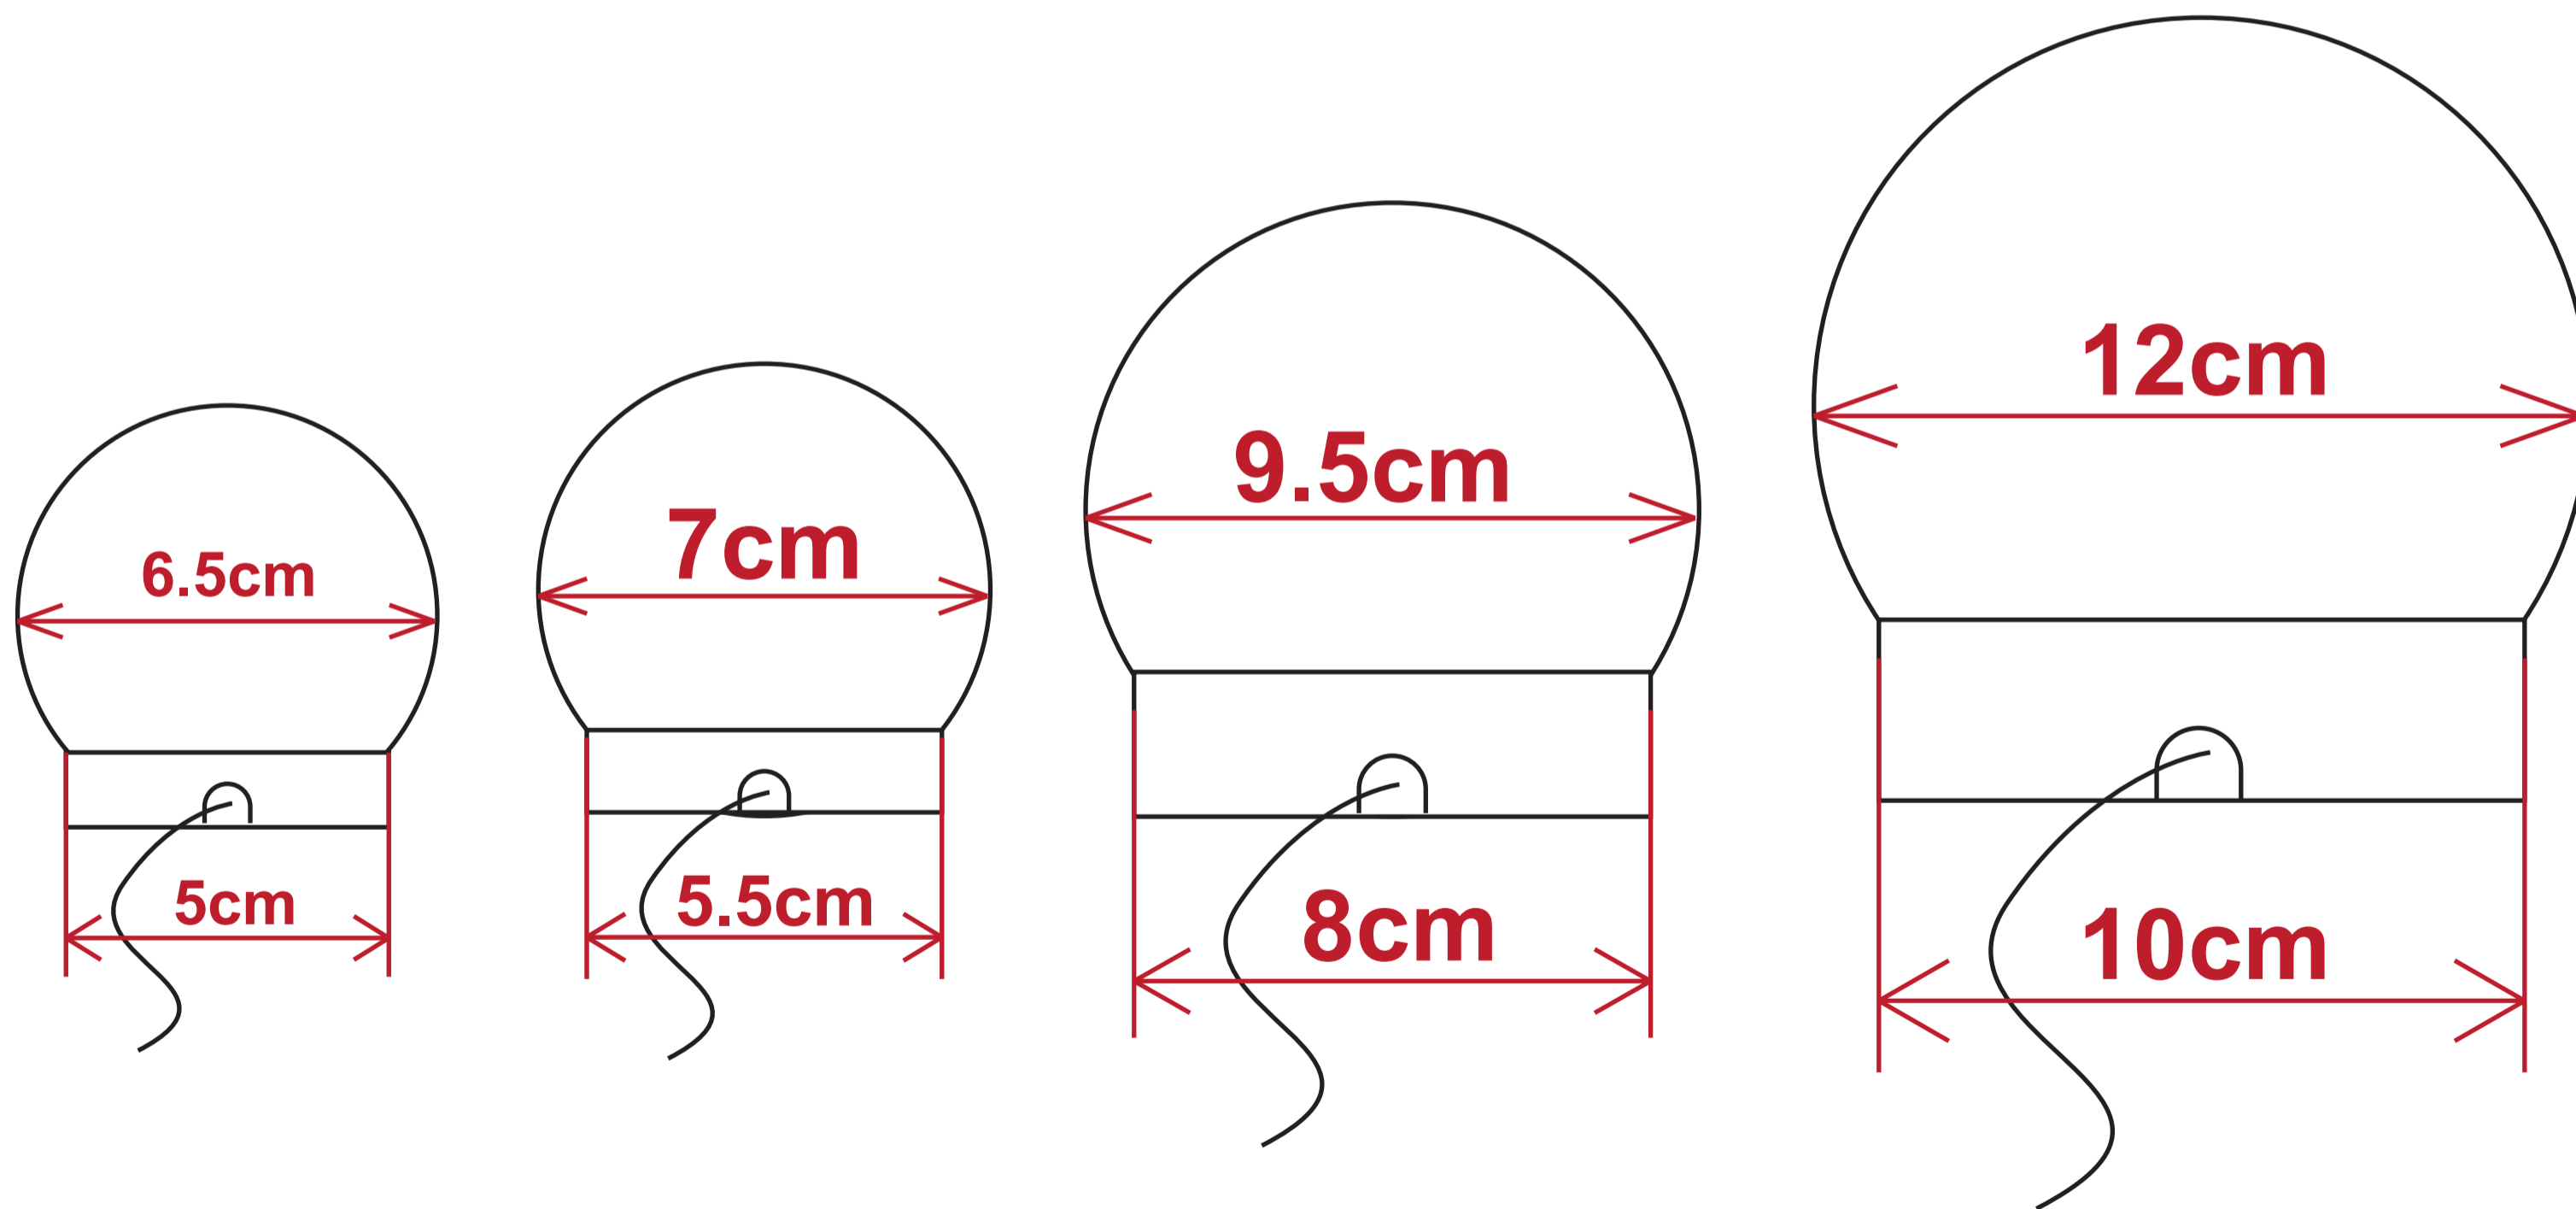
Recommended stroke needs to be 10mm larger than bulb size

Recommended stroke needs to be 10mm larger than bulb size
